1 ENGINEER'S DRAINAGE CERTIFICATION FOR TEMPORARY CERTIFICATE OF OCCUPANCY FOR BUILDINGS 4 AND 6

3 ENGINEER'S CERTIFICATION FOR PERMANENT CERTIFICATES OF OCCUPANCY FOR BUILDINGS 1-6

ENGINEER'S CERTIFICATION OF GRADING AND DRAINAGE

LA CUEVA OFFICE PARK - BUILDINGS 1-6
8300 CARMEL AVE. N.E. - SUITES 101-601

TITLE OF SHEET
GRADING PLAN

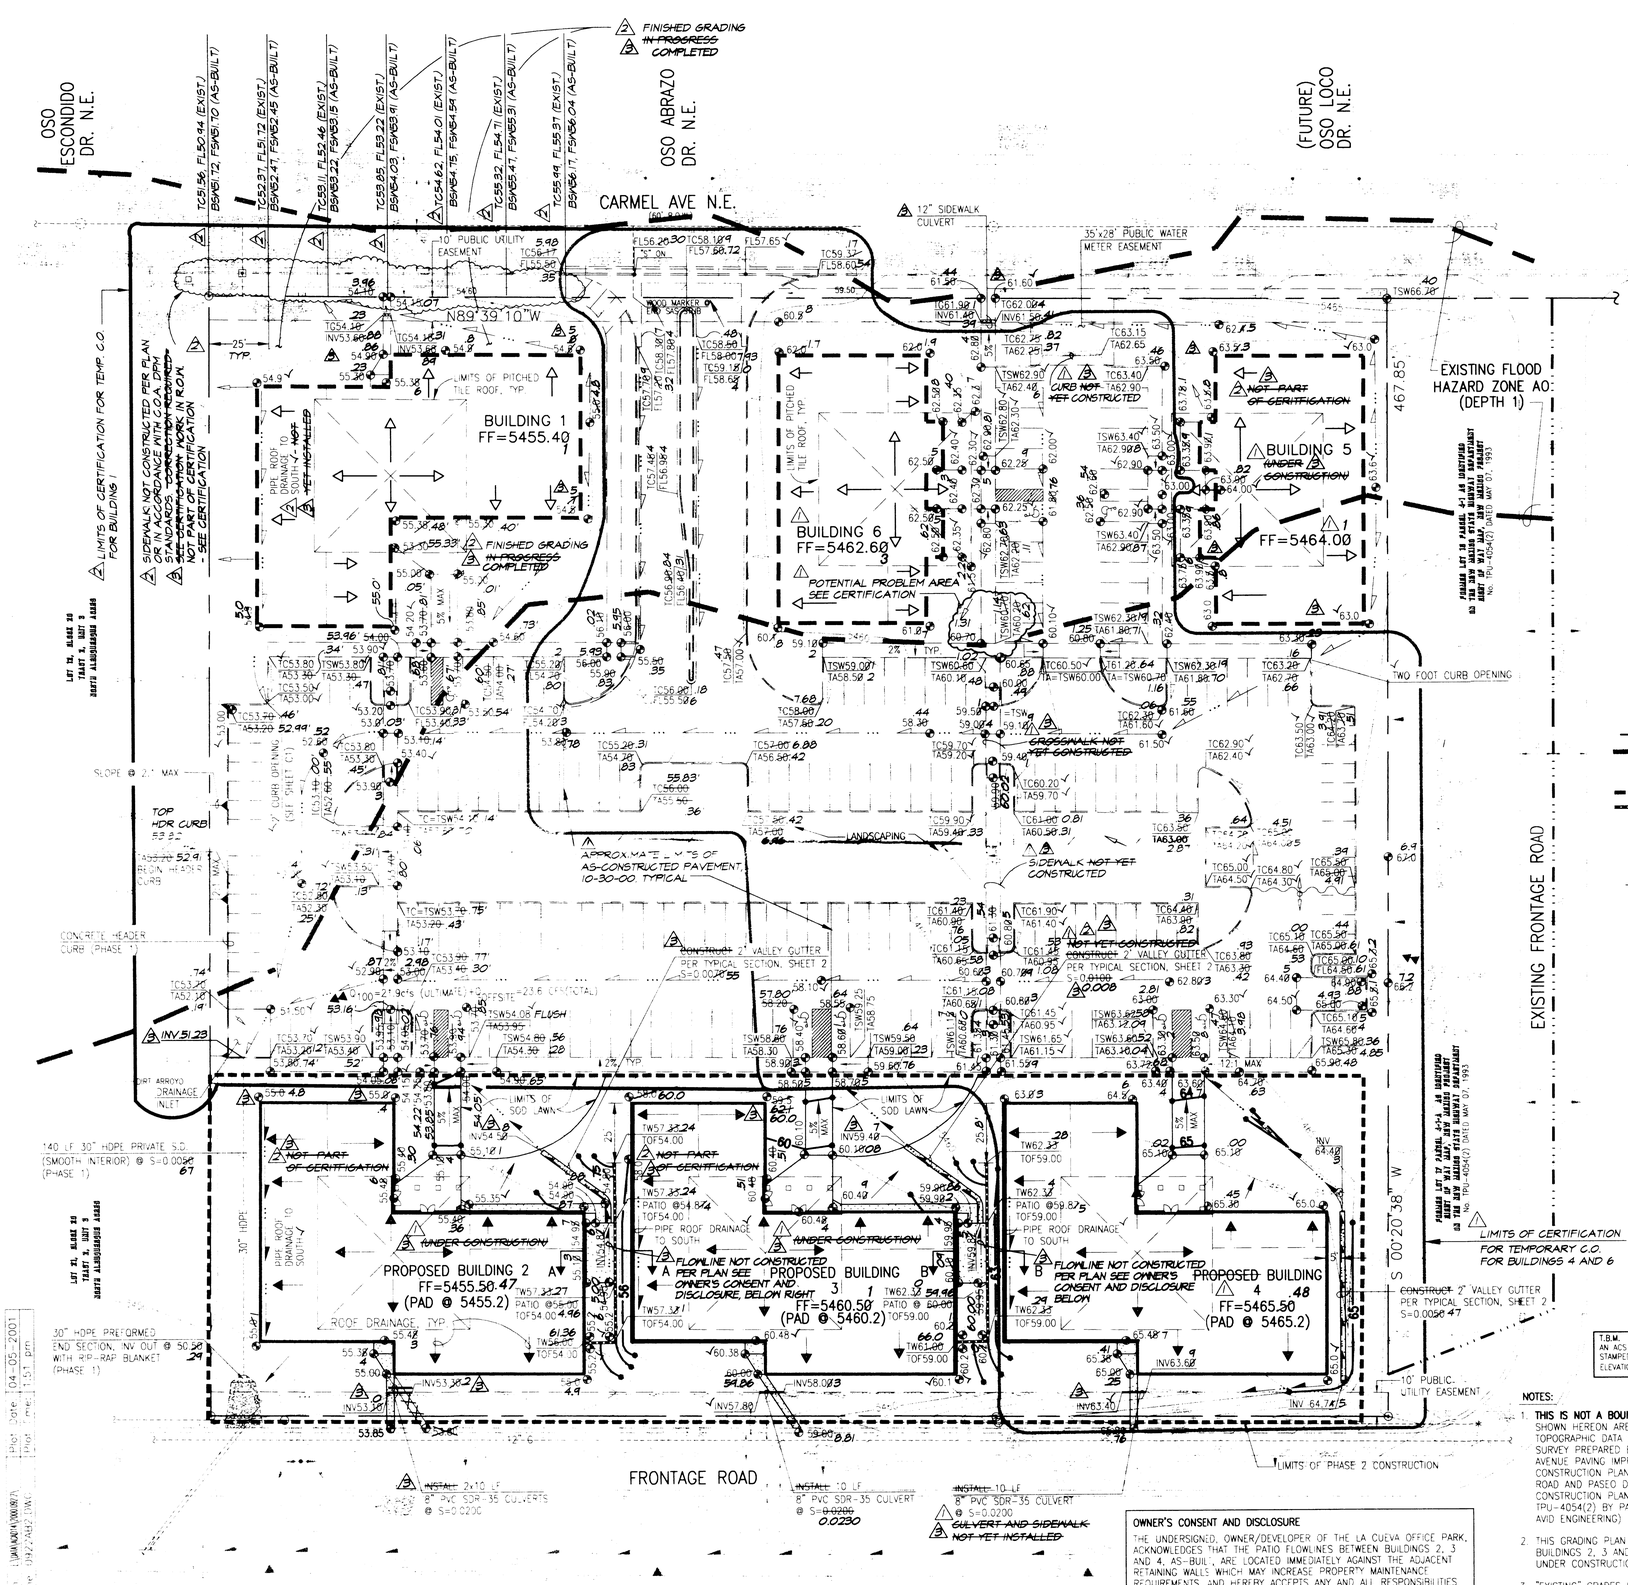
THE AS-CONSTRUCTED LOCATIONS OF THE PATIO FLOWLINES VARY FROM THOSE SHOWN ON THE APPROVED GRADING PLAN. WHILE SATISFYING THE INTENT OF THE APPROVED PLAN WITH RESPECT TO DRAINAGE, THIS VARIATION, MAY CAUSE INCREASED SITE MAINTENANCE. THE PROPERTY OWNER HAS ACKNOWLEDGED THIS CONDITION AND HAS ACCEPTED RESPONSIBILITY FOR THIS CONDITION (SEE OWNER'S CONSENT AND DISCLOSURE, SHEET 2).

THE AS-CONSTRUCTED LOCATIONS OF THE PATIO FLOWLINES VARY FROM THOSE SHOWN ON THE APPROVED GRADING PLAN. WHILE ACHIEVING THE INTENT OF THE APPROVED PLAN WITH RESPECT TO DRAINAGE, THIS VARIATION, MAY CAUSE INCREASED SITE MAINTENANCE. THE PROPERTY OWNER HAS ACKNOWLEDGED THIS CONDITION AND HAS ACCEPTED RESPONSIBILITY FOR THIS CONDITION (SEE OWNER'S CONSENT AND DISCLOSURE, SHEET 2)

THE UNDERSIGNED, OWNER/DEVELOPER OF THE LA CUEVA OFFICE PARK, ACKNOWLEDGES THAT THE PATIO FLOWLINES BETWEEN BUILDINGS 2, 3 AND 4, AS-BUILT, ARE LOCATED IMMEDIATELY AGAINST THE ADJACENT RETAINING WALLS WHICH MAY INCREASE PROPERTY MAINTENANCE REQUIREMENTS, AND HEREBY ACCEPTS ANY AND ALL RESPONSIBILITIES ASSOCIATED WITH THIS DEVIATION FROM THE APPROVED PLAN.

SECTION A-A

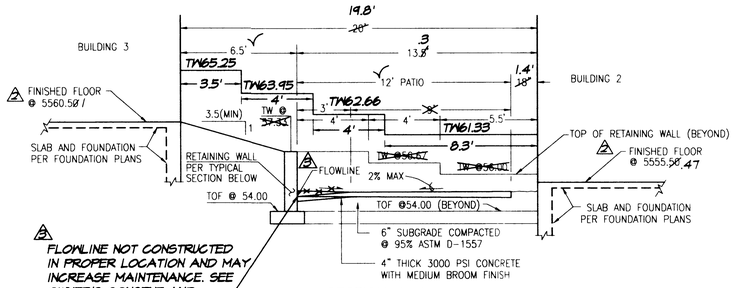
NOT YET CONSTRUCTED

SECTION B-B

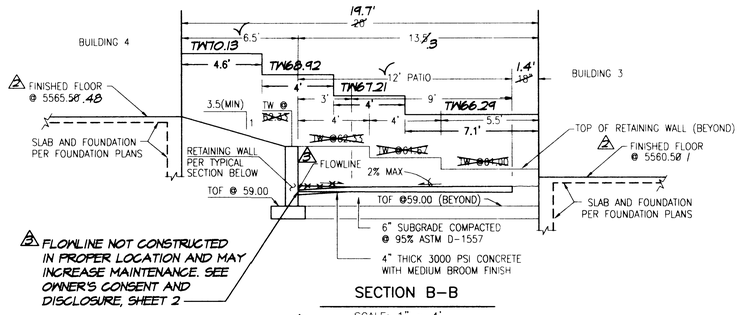
NOT YET CONSTRUCTED

TYPICAL RETAINING WALL SECTION

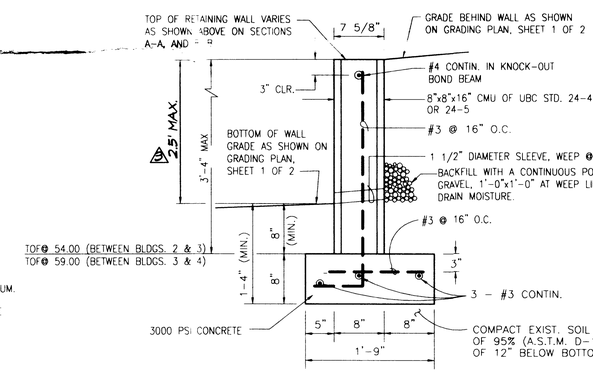
NOT YET CONSTRUCTED

SECTION A–A

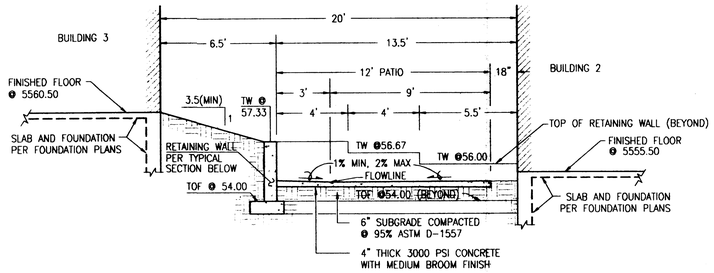
⚠ NOT YET CONSTRUCTED
